RE: RMA/2024/2333 – INTERIM REQUEST FOR FURTHER INFORMATION – 229 KAITUNA VALLEY ROAD

The purpose of this letter is to provide a response to Christchurch City Council's formal request for further information (RFI) of 3 October 2024 regarding the proposed wintering barn, underpass, and associated infrastructure at 229 Kaituna Valley Road (RMA/2024/2333).

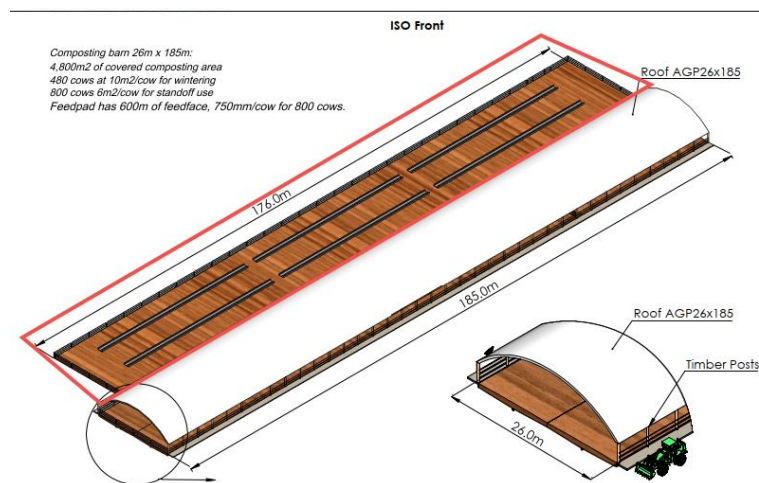
- a) *The wintering barn dimensions. Varying sections in the application documents state the height to be 7.7m, 8m and 8.05m.*

For certainty, it is confirmed that the maximum height of the wintering barn will not exceed 8m. This was the height referenced and assessed within the Landscape Visual Assessment.

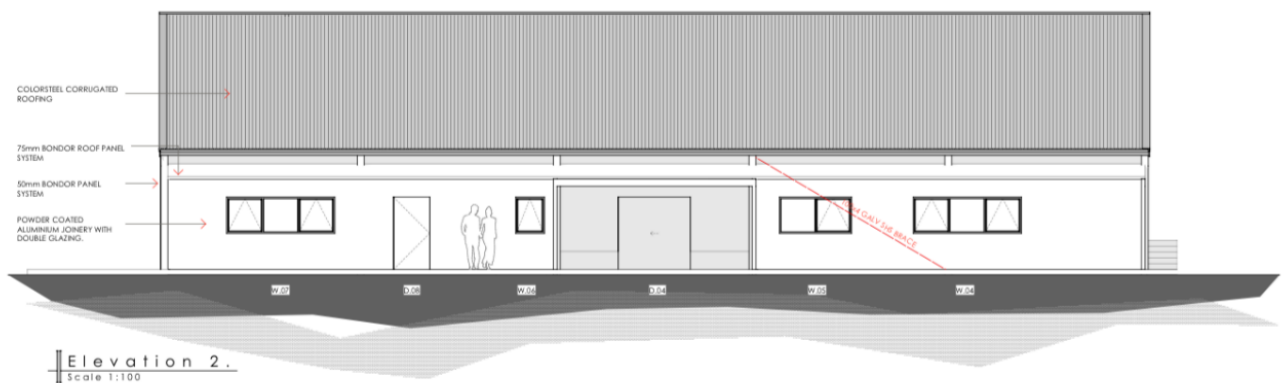
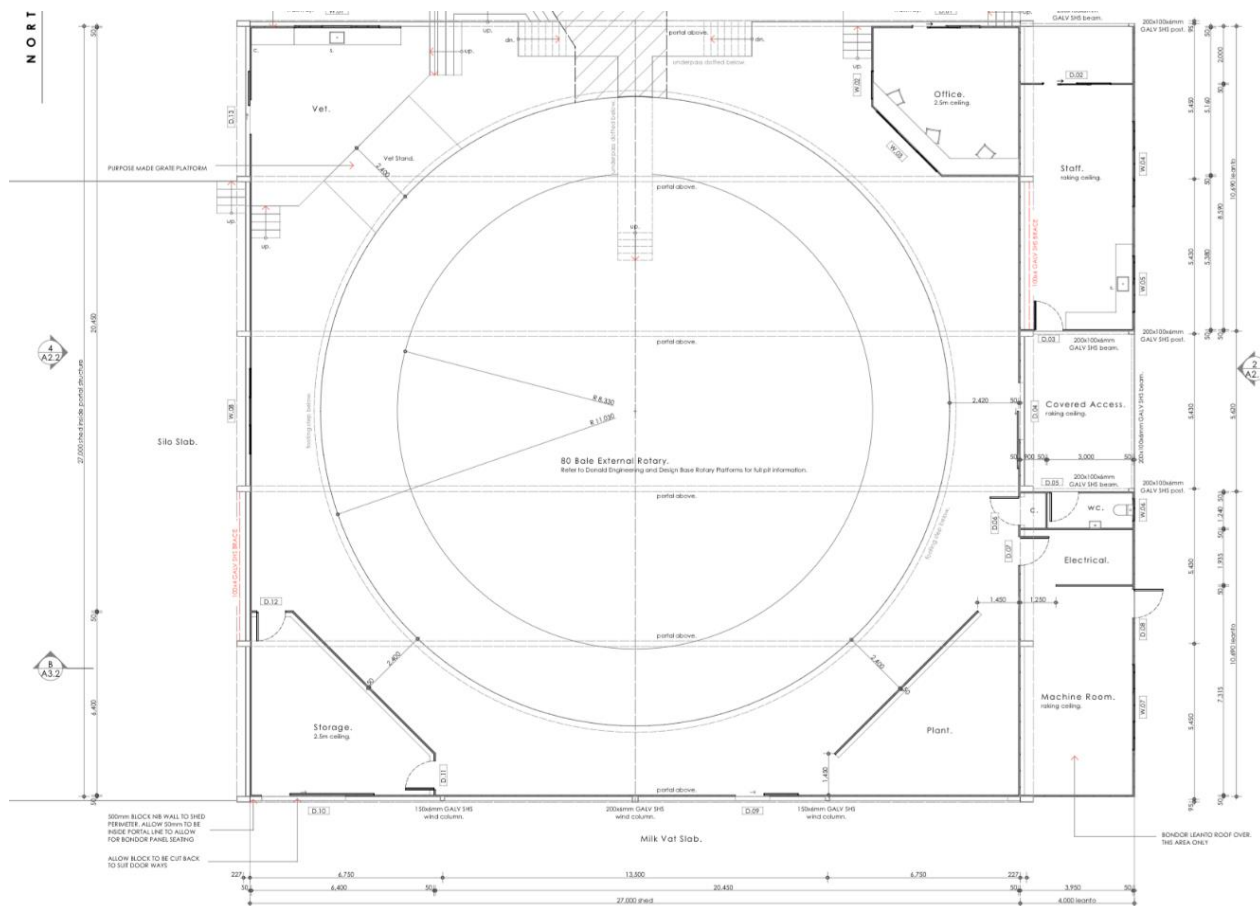
2. *Please provide plans and elevations for the dairy shed and associated infrastructure. Spec drawings will also be acceptable. Reason (for 1& 2): to gain an understanding of the full visual appearance of the proposal and for accuracy and consistency. The photograph provided to date is acknowledged, however it does not provide adequate information as to all the structures proposed.*

The dairy shed has not been subject to detailed design to date, so a generic maximum building envelope approach has been used instead. That said, dairy sheds are an extremely common sight within rural zones throughout the country and the size and appearance of this shed will be similar noting that this location will be considerably screened by the existing and proposed shelter belts which will be maintained at a height of at least 6m.

For clarity, the dairy shed building is expected to be no larger than 837m², and height of no greater than 5m above existing ground level. Spec drawings that have formed the basis for the proposed dairy shed building envelope are based on a rotary milking platform and provided below. The external design is also expected to be very similar to these spec drawings. The applicant confirms that the proposed dairy shed building will be no larger than the envelope proposed and would be willing to accept a condition to this effect.
